City of Bixby Planning Commission Meeting Agenda

Monday, July 21, 2025

- 1) Discussion and possible action regarding the incorporation of the Greyhawk Interceptor Sewer Basin into the City's Excess Capacity Fee Structure.
- 2) Discussion, consideration, and possible action for Final Plat BXPT-22.17 FP, submitted for The Reserve at Cedar Ridge, a proposed private residential development located approximately half a mile east of South Mingo Road, near the 10500 block of East 121st Street South.

CHECK-PRINT
FOR RED-LINE AND APPROVAL
NOT FOR CONSTRUCTION

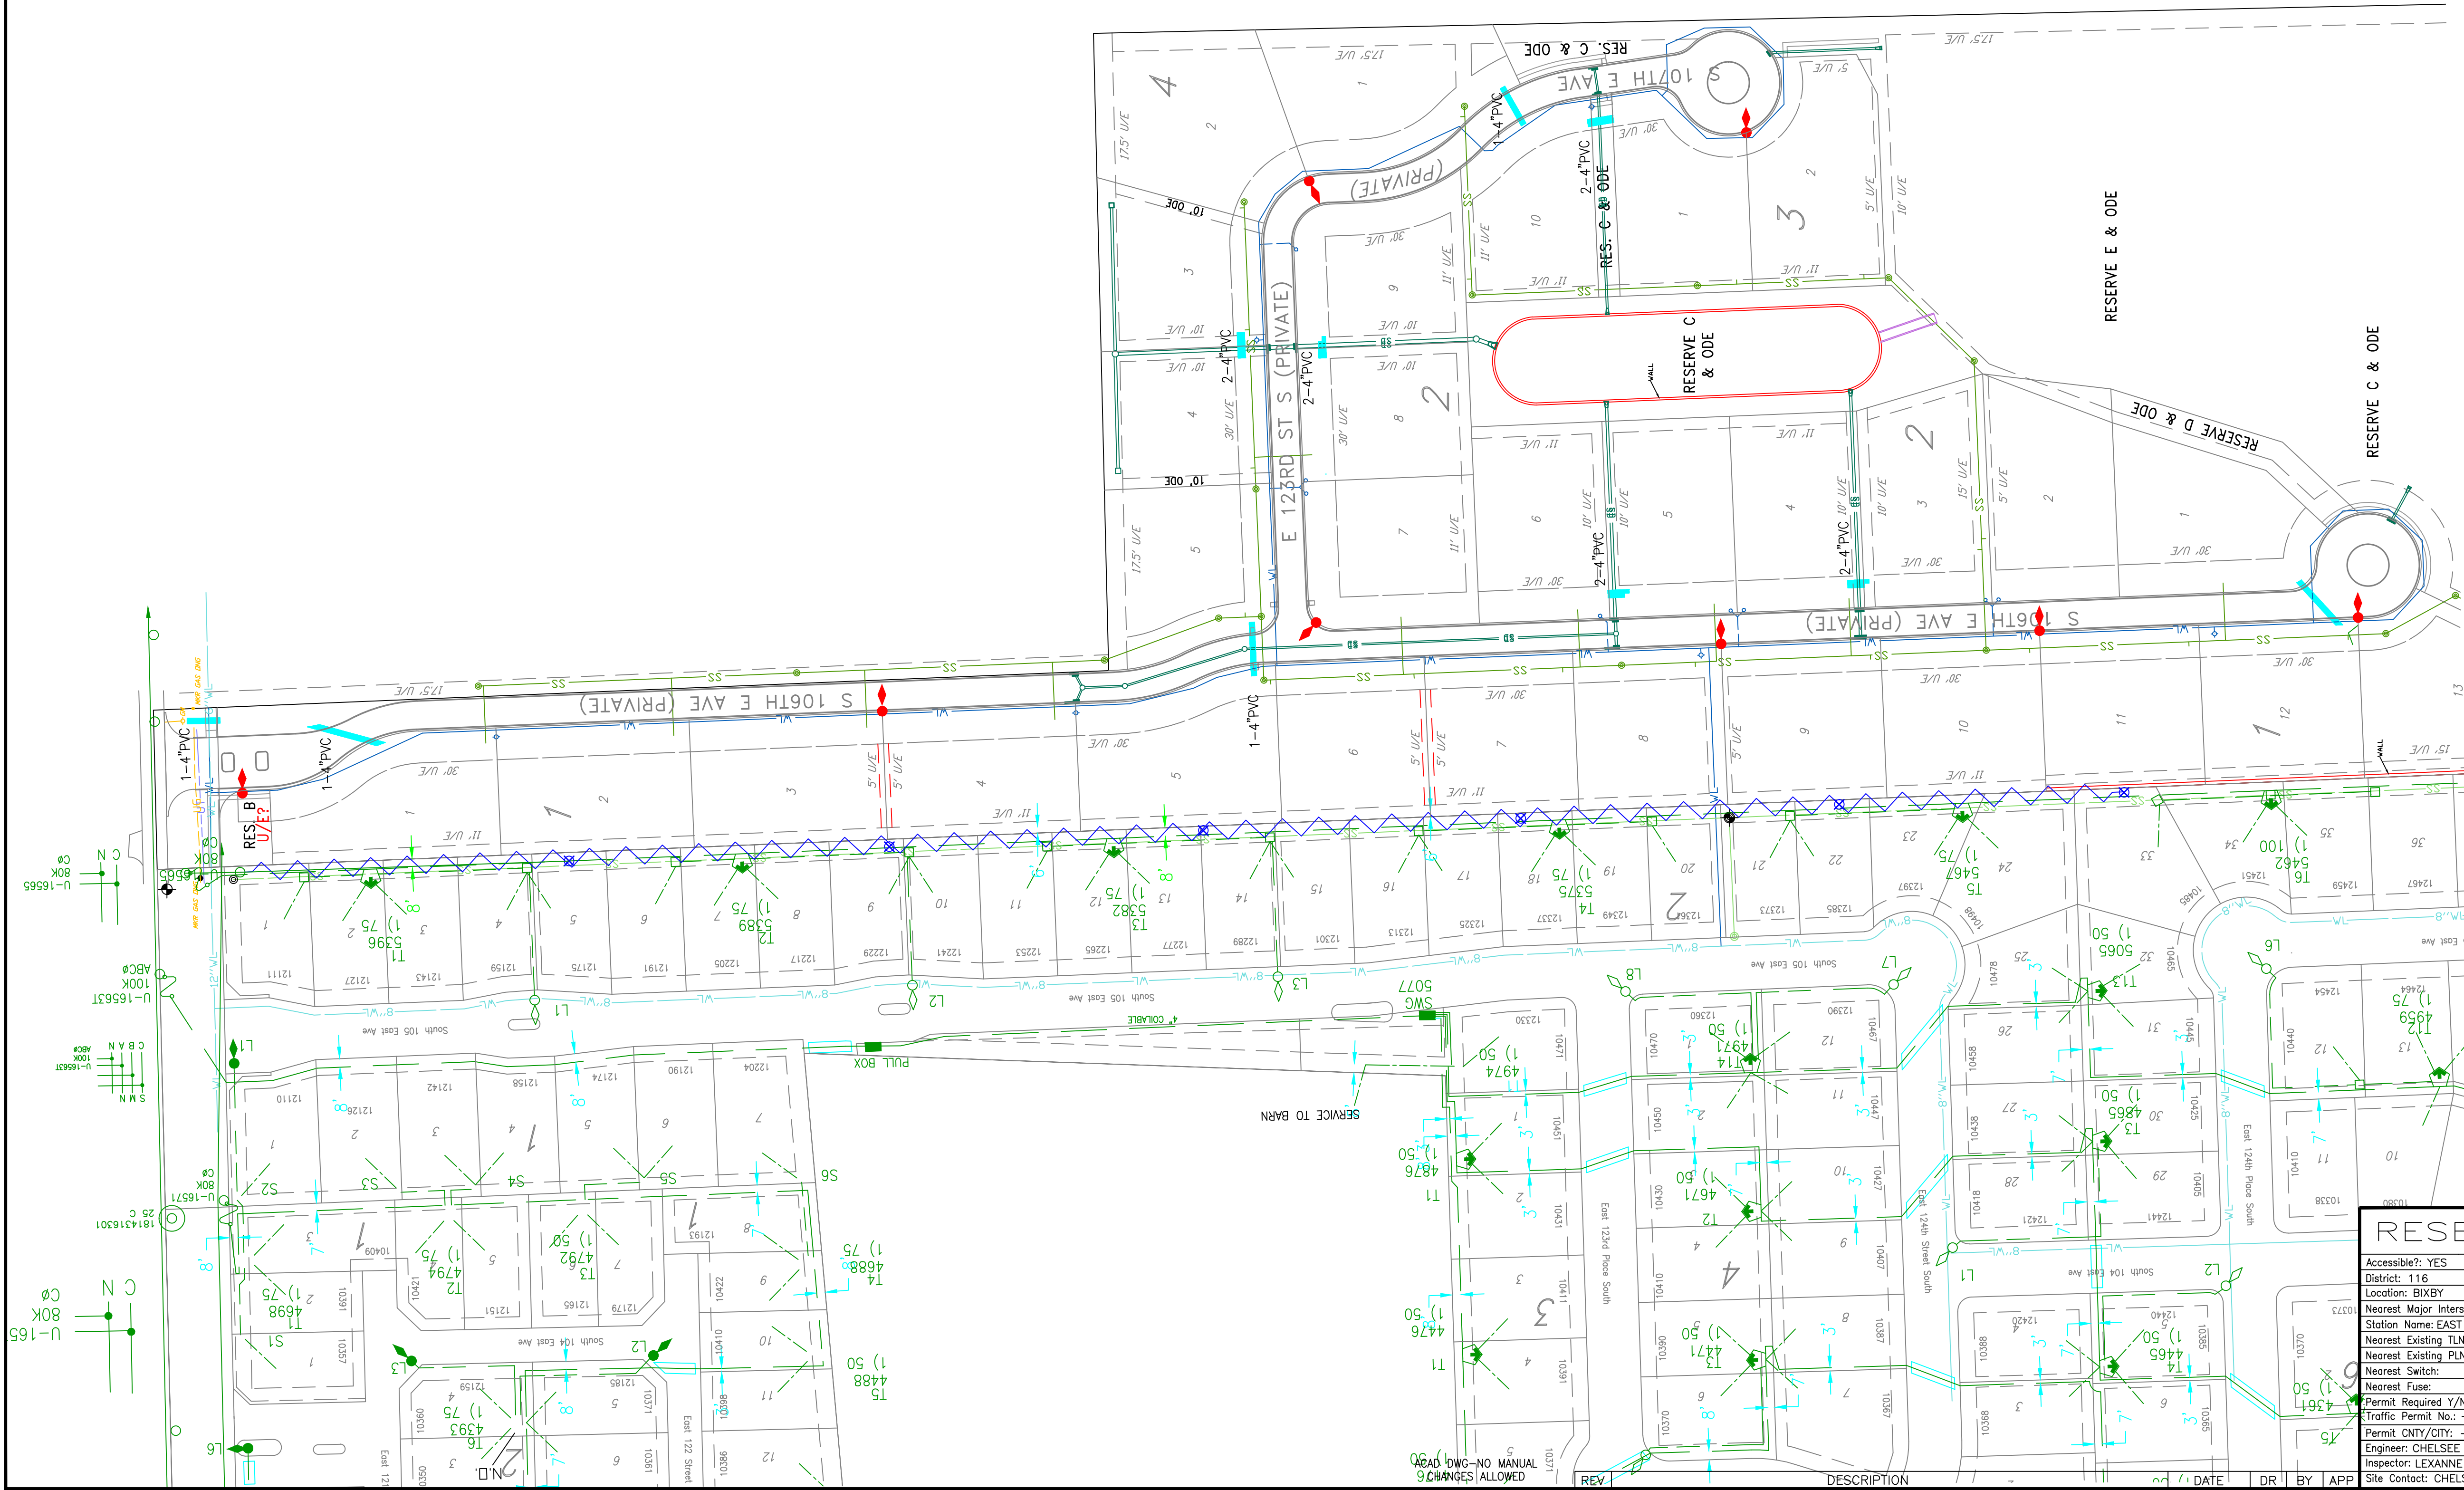
Responses	Noted.
Comment	<i>I was unable to find a copy of the Lighting Plan in our Records. Please submit a copy before final approval of the Plat.</i>

Of these Comments, only Bullet Points 4 and 5 and Comment # 27 would impact the final plat. In addition, note that a 17.5' perimeter U/E has only been provided on the north, east, and south boundaries. Only Utility easements with widths of 11' and 15' are provided on the west boundary.

- a. Increasing the U/E on the western boundary to 17.5' U/E
- b. Matching and aligning the 11' U/E lines from Lots 20 and 21, Block 2 with a comparable, straight 22' U/E corridor Chisholm Ranch in Lots 8 and 9, Block 1, Reserve at Cedar Ridge for future maintenance.
- c. Listing backflow preventers on the face of the Plat as appropriate.
- d. Submitting a Lighting Plan

- d. Submitting a Lighting Plan
Agreed to do this at TAC. I requested this from AEP-PSO 06/04/2025 and 06/10/2025 and 06/20/2025. We will get this to you as soon as we receive it from them. Since we are at the mercy of and on their timeline, if necessary, I trust this can be submitted after PC and CC approval of our Final Plat but before the plat is signed and released for filing.

Figure 2: Existing and Proposed Utilities

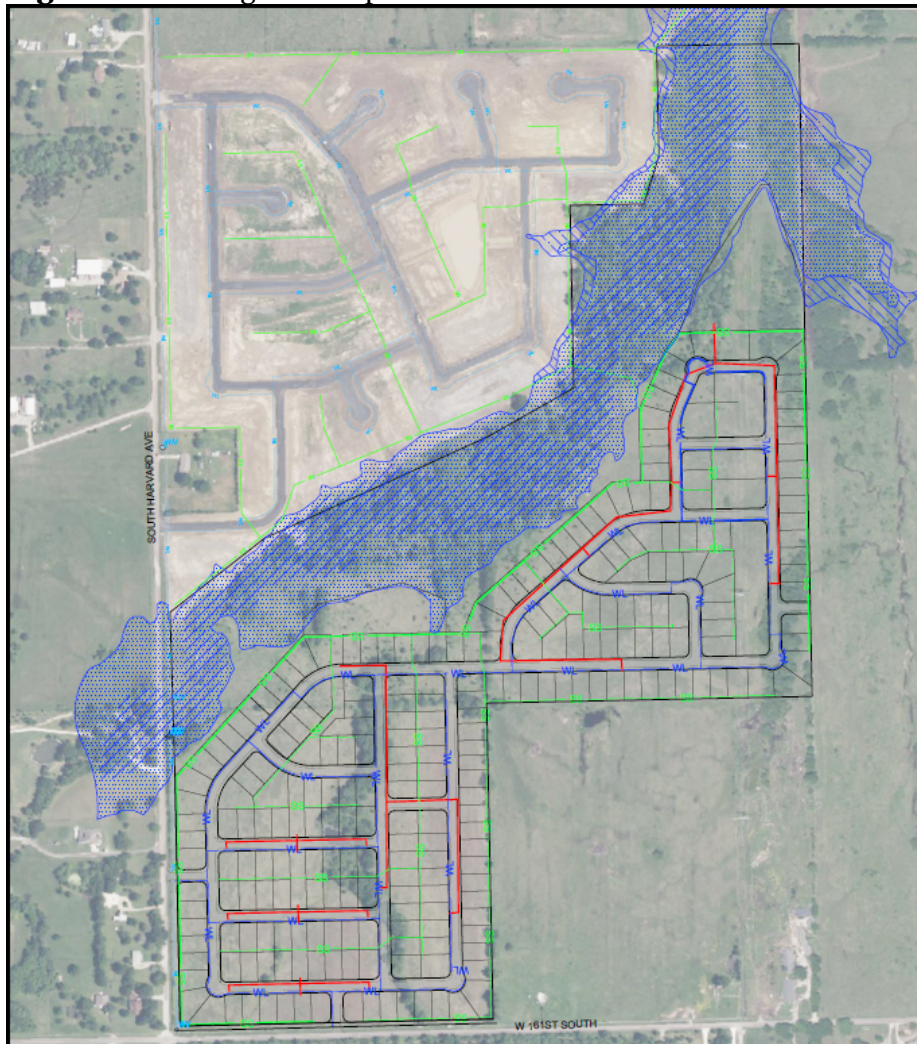
- Update all exhibits to show the accurate project location, as the current maps are incorrect.
- As requested by the City Council on February 24, 2025, the PUD amendment will include the addition of left turn lanes and deceleration lanes at both entrances on South Harvard Avenue and East 161st Street.
